Work Order ID 147834

Item Name: Crosstube Turning Detail

DART AEROSPACE LTD		Work Order: 147834
Description: Crosstube Assembly		Part Number: D407-667-145
Inspection Dwg: D407-667-145 Rev: C		Page 1 of 2

DRAWING NO. D407-667-145	TITLE CROSSTUBE ASS'Y (407 HIGH FWD)	REV. C	DART AEROSPACE LTD ENGINEERING ORDER		D.E.O. NO. D407-667-145-C-1	SHEET NO. SHEET 1 OF 1	SCALE NTS
DRAWN <i>q</i>	CHECKED <i>ASS</i>	MFG. APPR. <i>IB</i>	APPROVED <i>WD</i>		DE APPR. <i>HA</i>		
DATE 11.07.15	DATE 11.07.22	DATE 11.07.22	DATE 11/07/22		DATE 11.07.21

C TURNING DETAIL

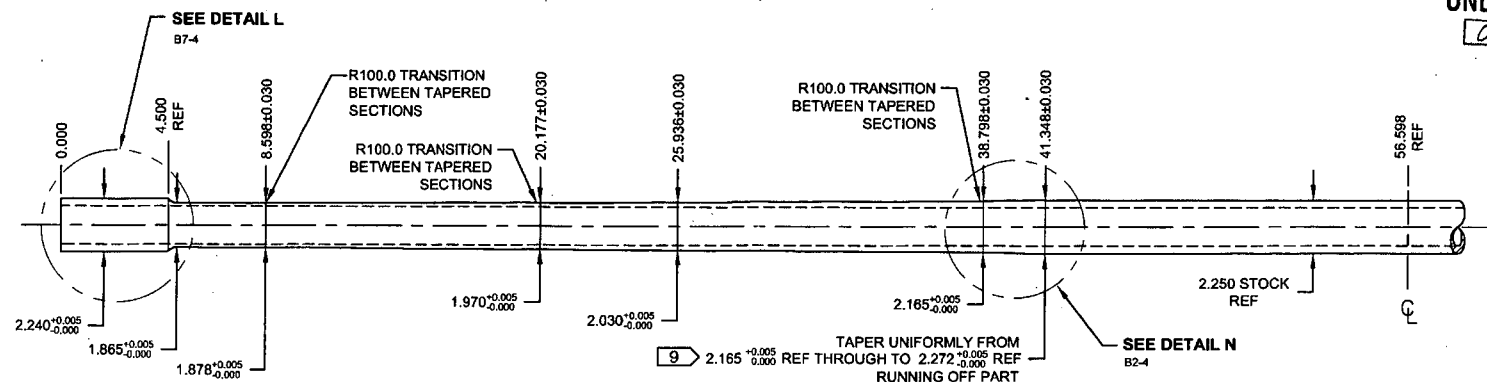
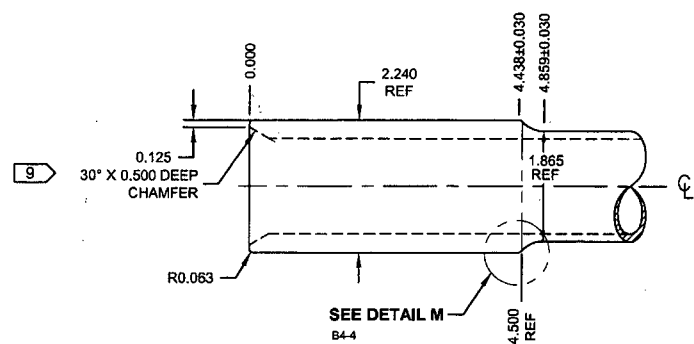
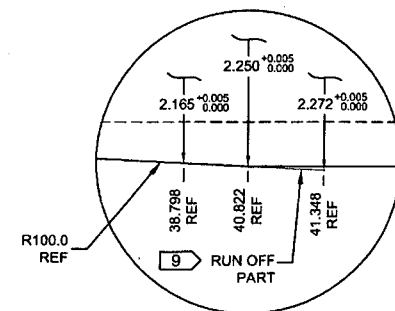
C	REVISE GENERAL NOTES/PART LIST (ZN D7-1); REORGANIZED VIEWS AND REFORMATTED DRAWING TO CURRENT STANDARDS. D3595-063-395 WAS D2856-400-894 (ZN D6-2 & A5-2); REMOVED REF. 7 ADD TOLERANCES (ZN C8-3, C4-3, D2-3); RELOCATED FLAG #6 (ZN A8-3) PER NCR 210; MOVED TURNING DETAIL & UPDATED TOLERANCE TO SHEET 4.	RF	08.11.06
B	ADD HOLES AND NUT PLATES FOR COMPATABILITY WITH BHT/AA SKUDTUBES	PH	05.07.26
A	NEW ISSUE	CP	02.05.08
REV.	DESCRIPTION	BY	DATE
DESIGN	0	DART AEROSPACE LTD	
DRAWN	RE	HAWKESBURY, ONTARIO, CANADA	
CHECKED	0	DRAWING NO.	REV. C
MFG. APPR.	0	D407-667-145	SHEET 1 OF 4
APPROVED	0	TITLE	SCALE
DE APPR.	0	CROSSTUBE ASS'Y (407 HIGH FWD)	NTS
DATE	08.11.06	COPYRIGHT © 2002 BY DART AEROSPACE LTD THIS DOCUMENT IS PRIVATE AND CONFIDENTIAL AND IS SUPPLIED ON THE EXPRESS CONDITION THAT IT IS NOT TO BE USED FOR ANY PURPOSE OR COPIED OR COMMUNICATED TO ANY OTHER PERSON WITHOUT WRITTEN PERMISSION FROM DART AEROSPACE LTD.

DETAIL P
 BONDING STRAP INSTALLATION 2 PL

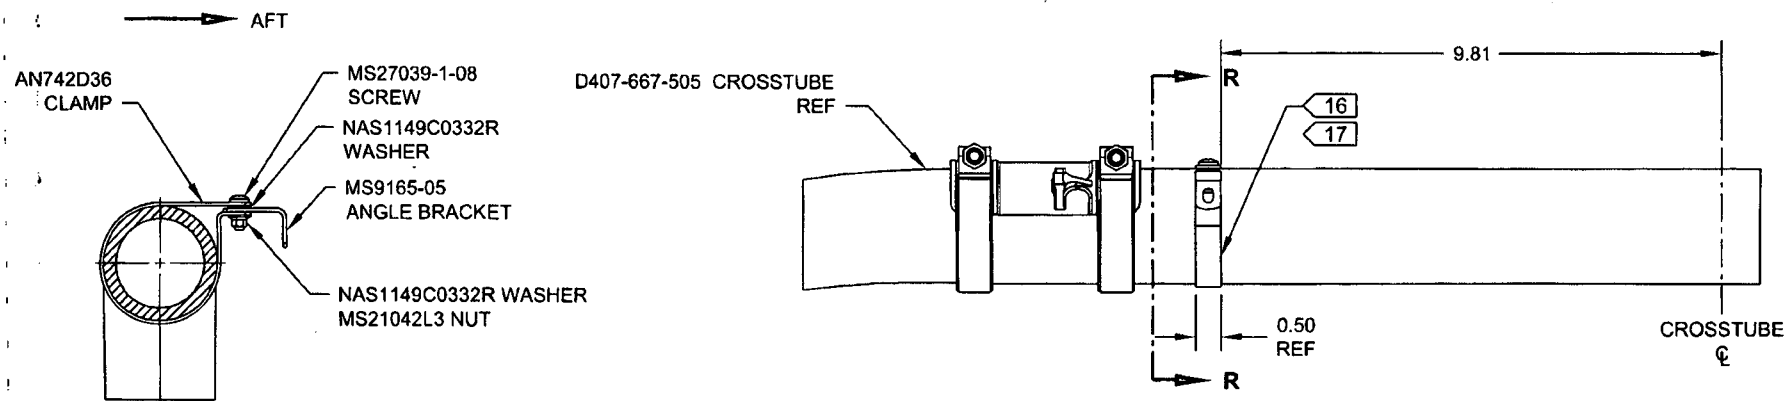
PURPOSE:

ADD ELECTRICAL GROUNDING STRAP

ITEM	QTY -145	PART NUMBER	DESCRIPTION	
1	X	D407-667-145	CROSSTUBE ASSEMBLY (407 HIGH FWD)	
10	2	AN742D36	CLAMP	} ADD
11	2	MS9165-05	ANGLE BRACKET	
12	2	MS21042L3	NUT (OR MS21042-3)	
13	2	MS27039-1-08	SCREW	
14	4	NAS1149C0332R	WASHER (OR AN960C10L)

- 16) MASK AREA UNDER CLAMP PRIOR TO PAINTING
- 17) SEAL EDGES WHERE AN742D36 CLAMP MEETS WITH THE CROSSTUBE USING SIKAFLEX-241/-291 OR MIL-S-8802 CLASS B2 OR PROSEAL 890 SEALANT
- 18) PERFORM RESISTANCE CHECK TO ENSURE MAX RESISTANCE IS 10 MILLIOHMS
